D206-667-147
Job Sheet 167821-E

Part Name: Crosstube Assembly, Mid Fwd

DRAWING NO. D206-667-147	TITLE CROSSTUBE ASS'Y (206L MID FWD)	REV. A	DART AEROSPACE LTD ENGINEERING ORDER		D.E.O. NO. D206-667-147-A-1	SHEET NO. SHEET 1 OF 1	SCALE NTS
DRAWN <i>q</i>	CHECKED <i>AS</i>	MFG. APPR. <i>AS</i>	APPROVED <i>MD</i>	DE APPR. <i>MD</i>			
DATE 11.07.15	DATE 11.07.20	DATE 11.07.21	DATE 11/07/21	DATE 11.07.21

DRAWING NO. D206-667-147	TITLE CROSSTUBE ASS'Y (206L MID FWD)	REV. A	DART AEROSPACE LTD ENGINEERING ORDER		D.E.O. NO. D206-667-147-A-2	SHEET NO. SHEET 1 OF 1	SCALE NTS
DRAWN AJS	CHECKED	MFG. APPR.	APPROVED	DE APPR.			
DATE 12.08.02	DATE 12.08.02	DATE 12.08.02	DATE 12.08.02	DATE 12.08.02	DATE 12.08.02

DETAIL P
BONDING STRAP INSTALLATION 2 PL

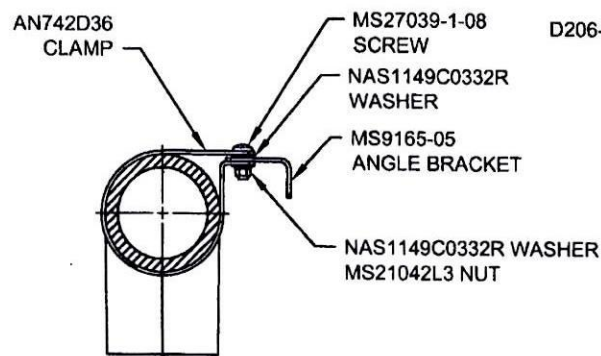
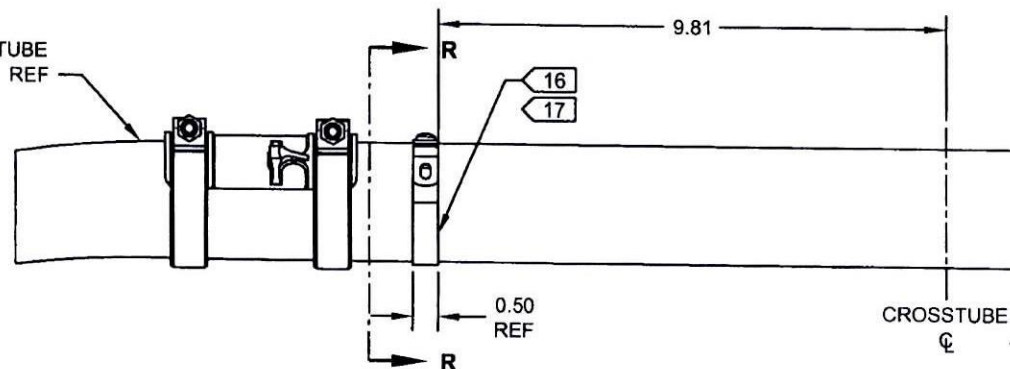
ADD ELECTRICAL GROUNDING STRAP

ADD

- 16) MASK AREA UNDER CLAMP PRIOR TO PAINTING
- 17) SEAL EDGES WHERE AN742D36 CLAMP MEETS WITH THE CROSSTUBE USING SIKAFLEX-241/-291 OR MIL-S-8802 CLASS B2 OR PROSEAL 890 SEALANT
- 18) PERFORM RESISTANCE CHECK TO ENSURE MAX RESISTANCE IS 10 MILLIOHMS
